ADDENDUM NO. 1

TO: PLANS AND SPECIFICATIONS FOR STATE OF MISSOURI

**Renovate Lobby and Restrooms 1st and 2nd Floor
Howerton State office Building
Jefferson City, Missouri
PROJECT NO.: O2339-01**

A-100

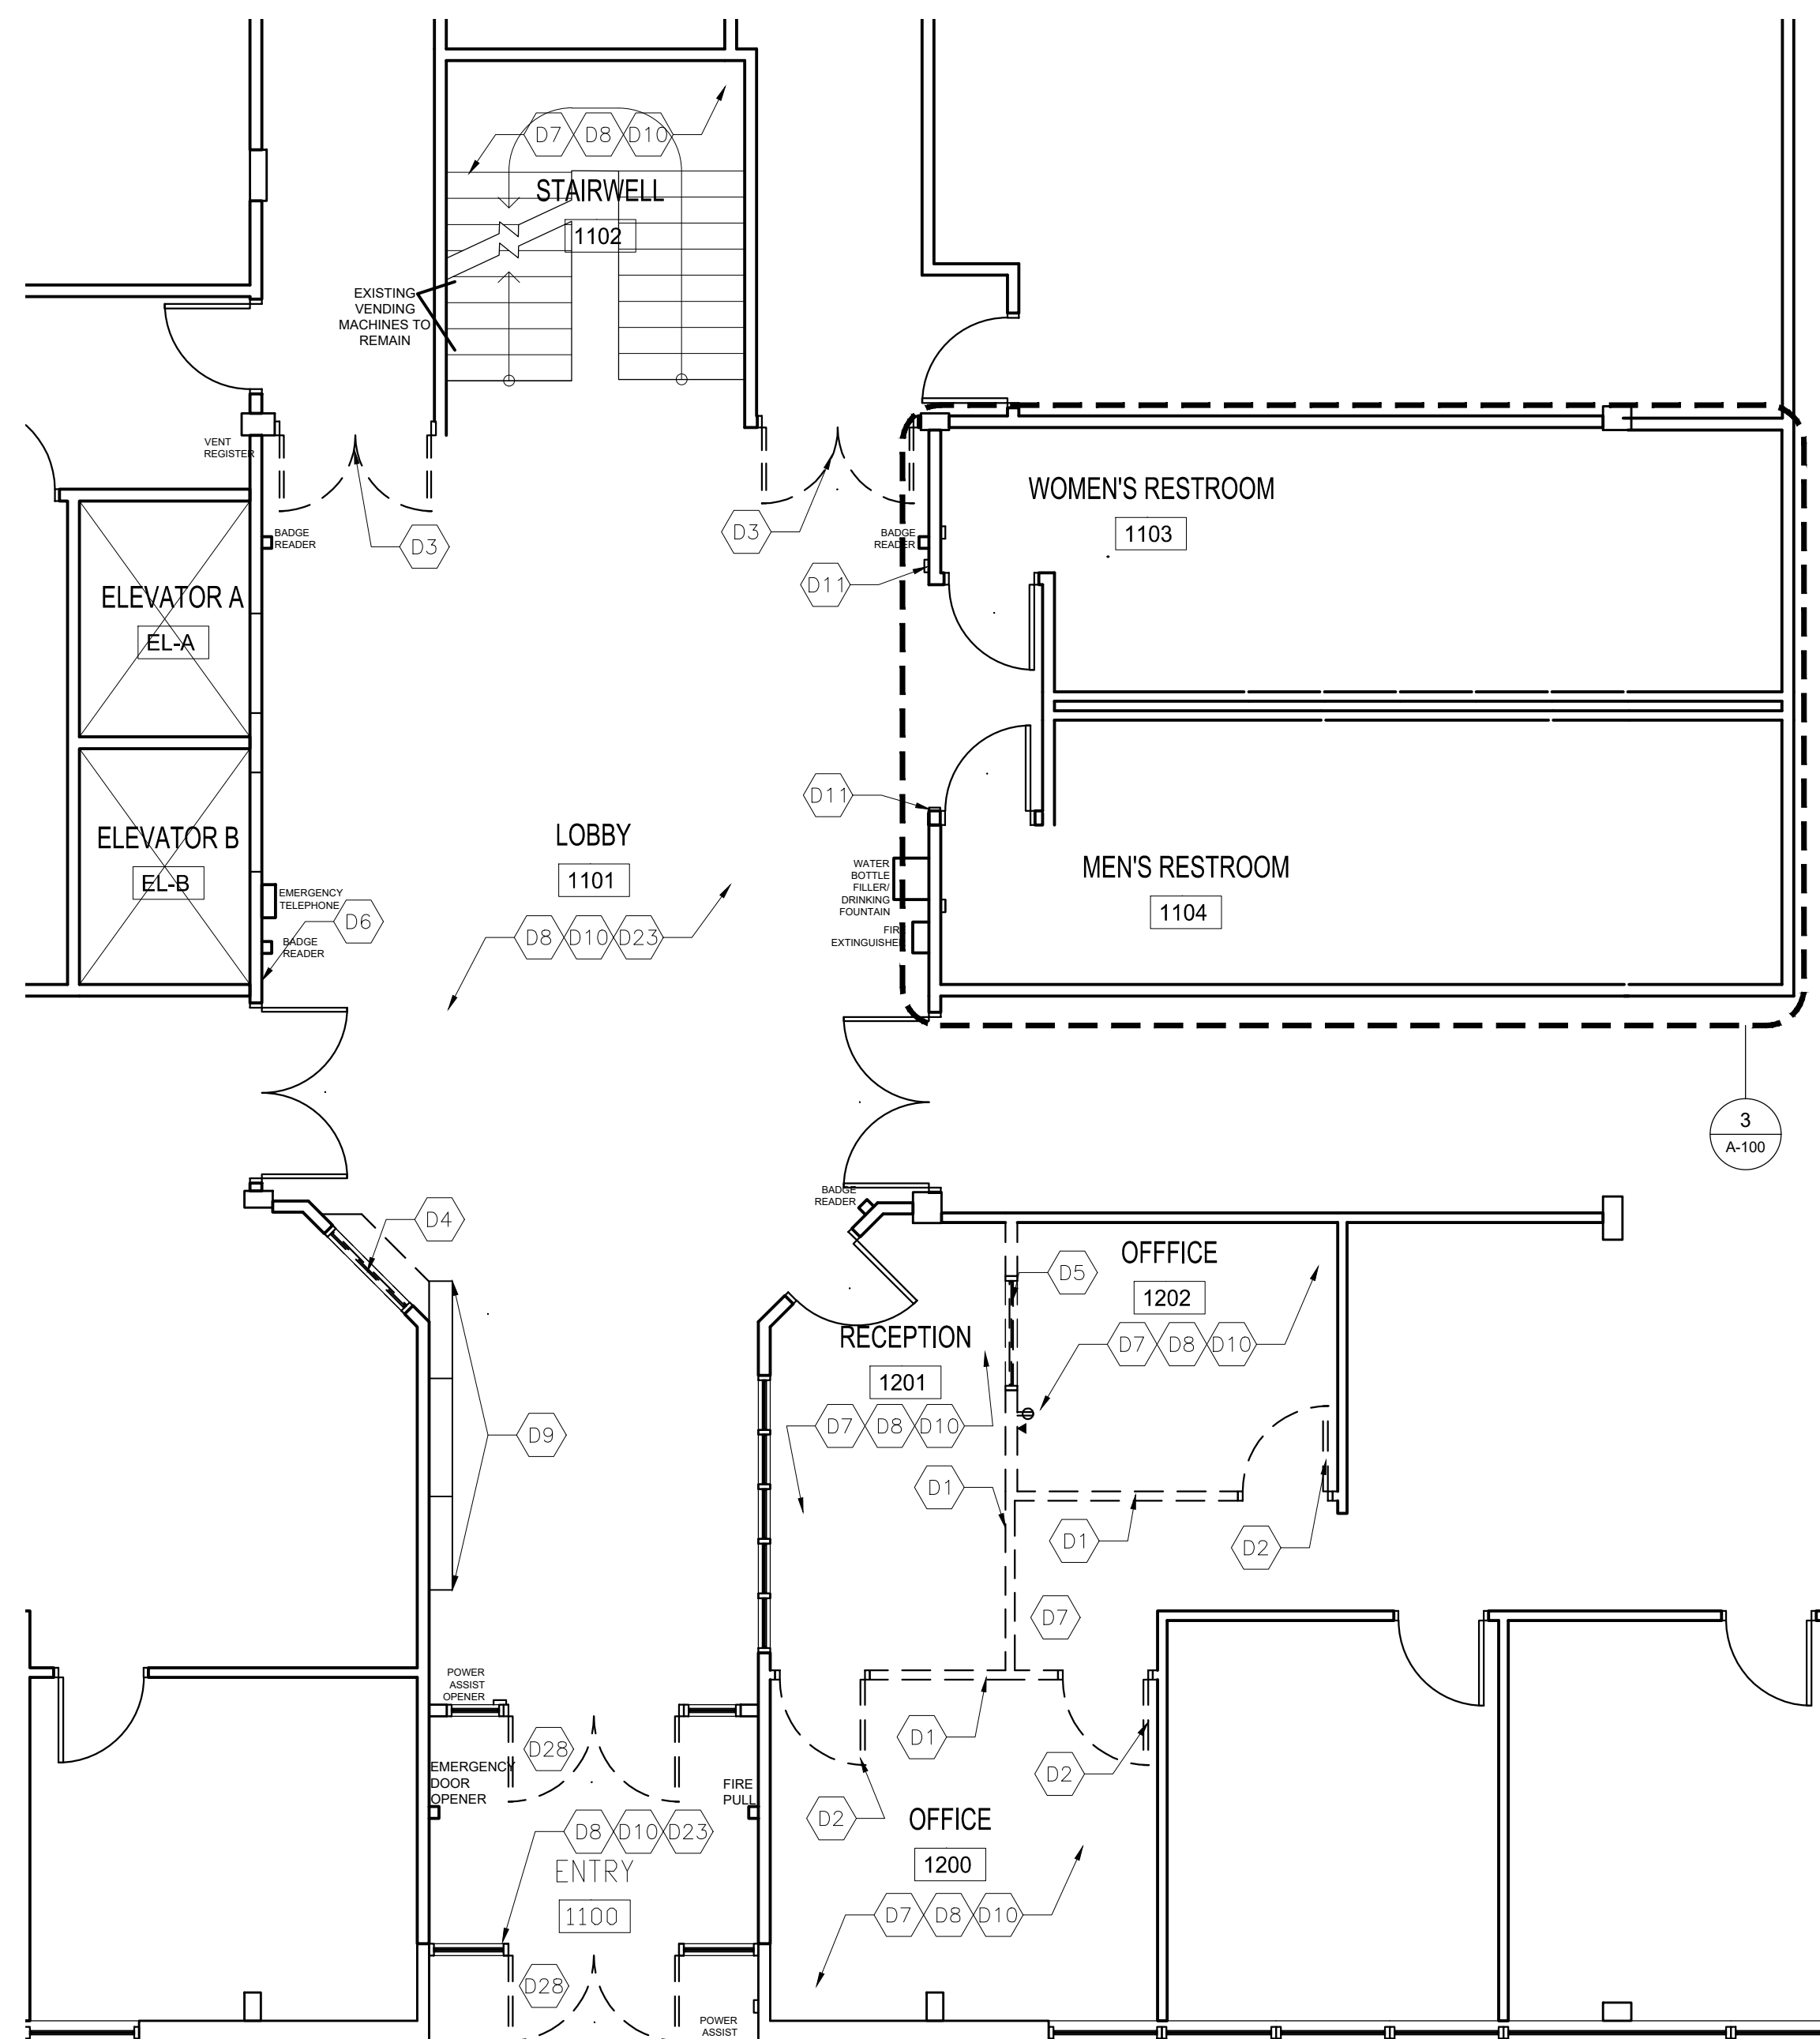
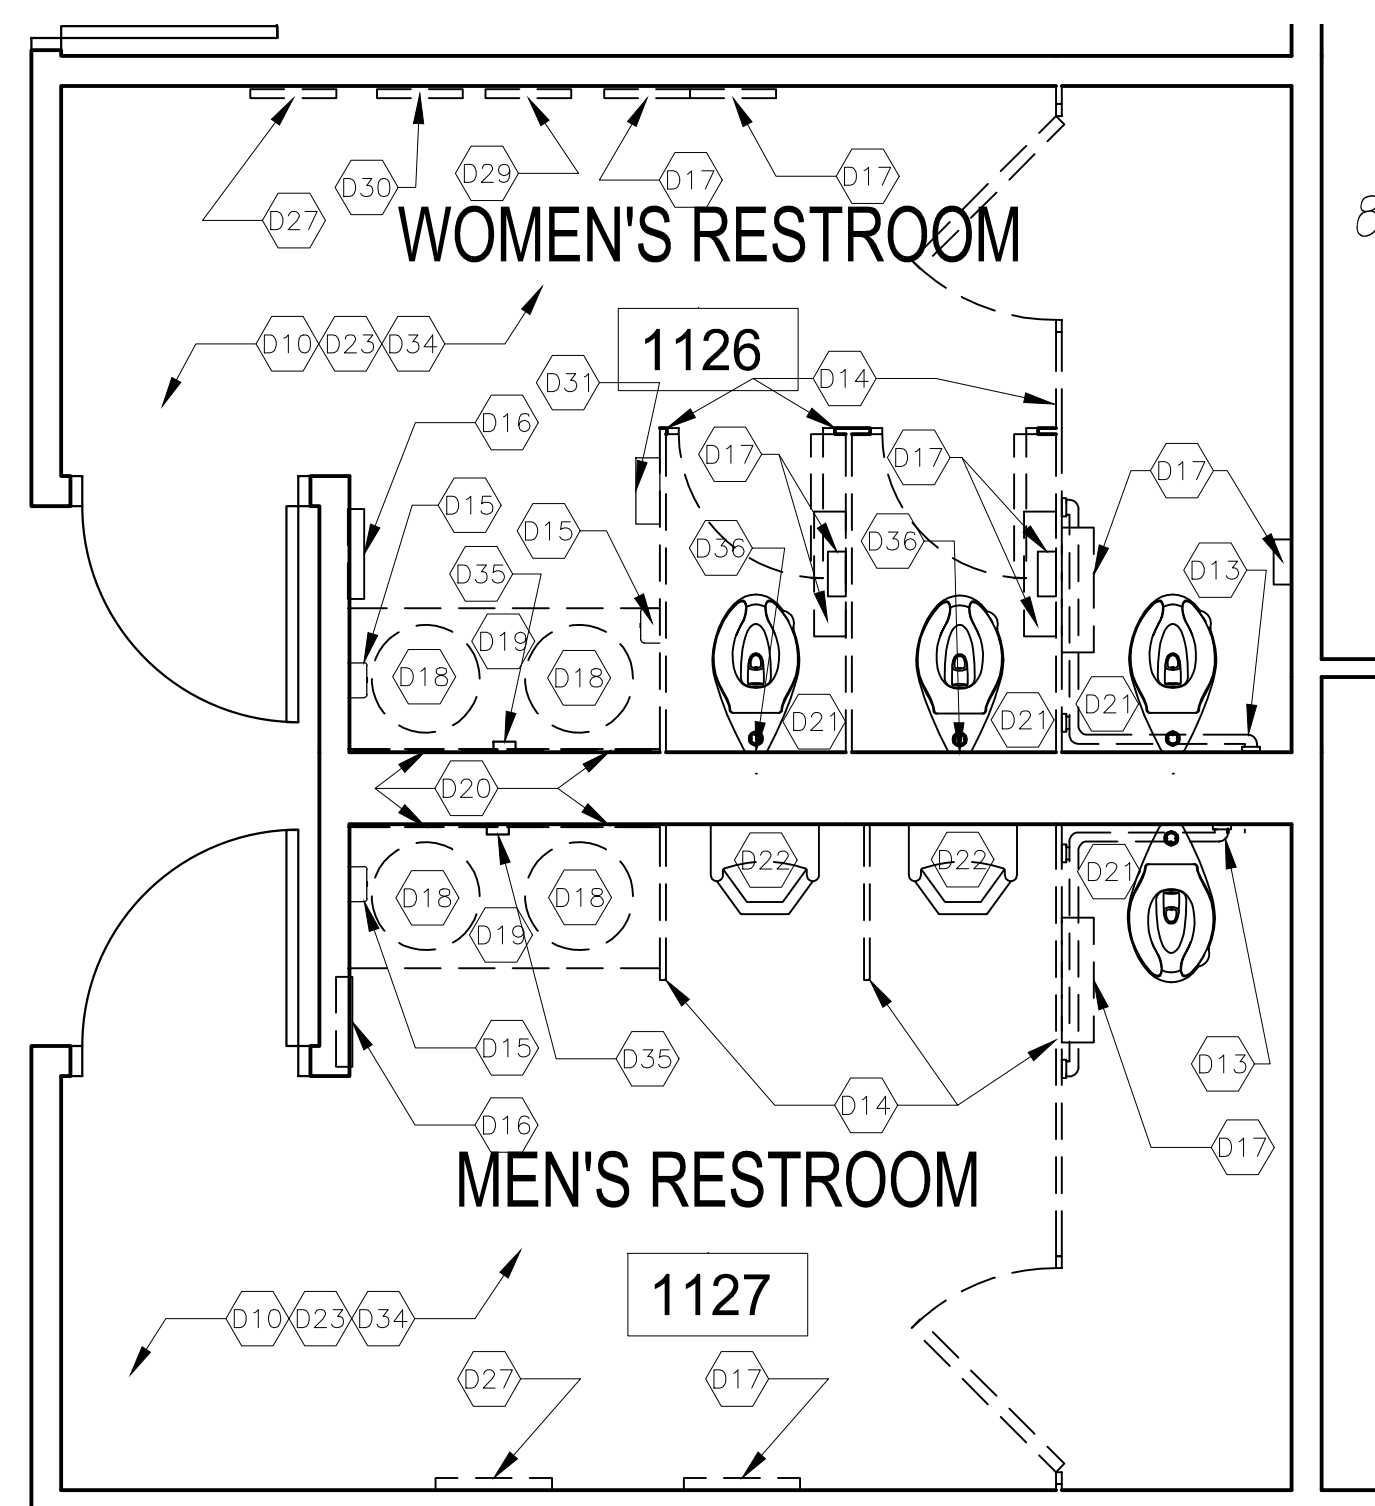
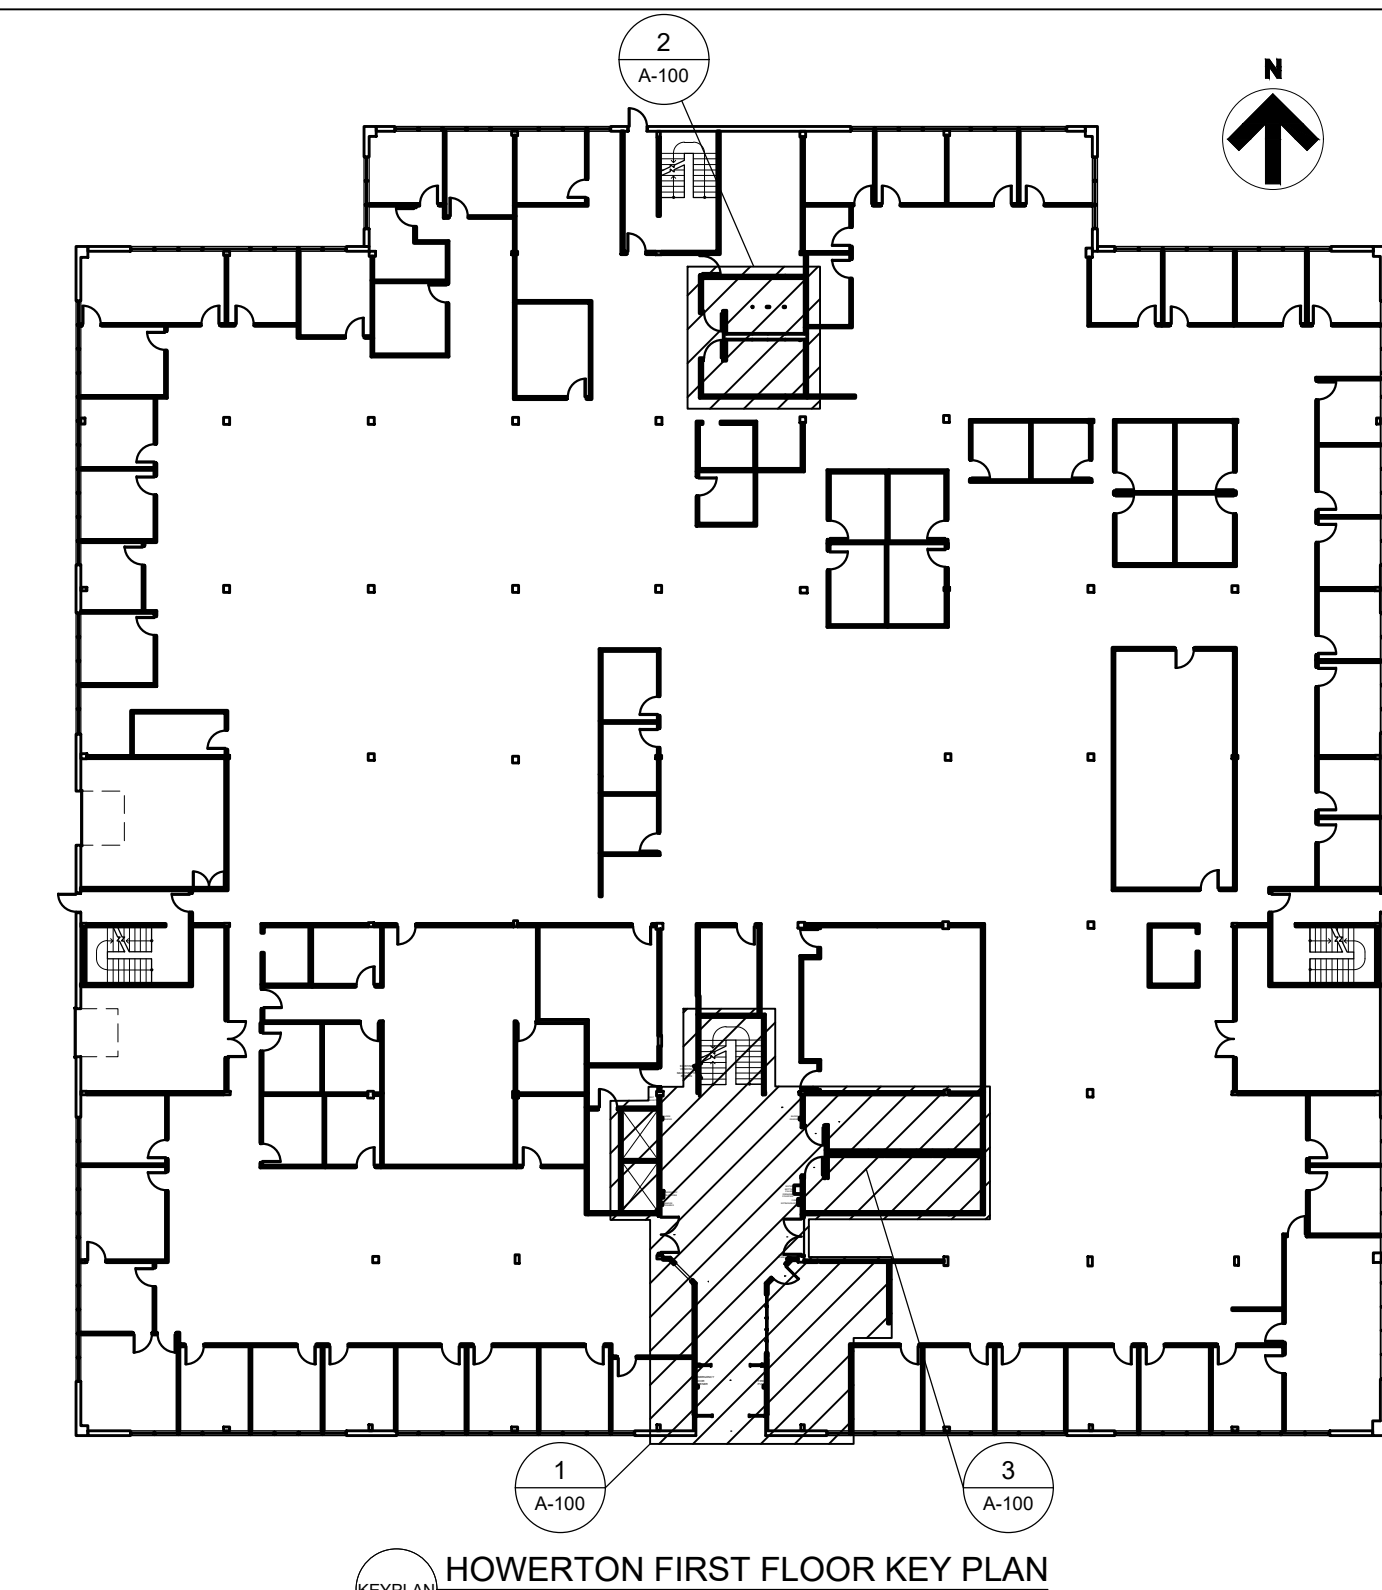
A-100

2. Demolition Plan Tag Note "D15" updated. No save for reuse.
3. Demolition Plan Tag Note "D16" updated. No save for re-use in same location.
4. Wall Symbol Key. Change demountable walls (existing base trim to be reused) to new walls. Change fixed gypsum metal studded walls (vinyl base cove to be replaced) to existing walls.
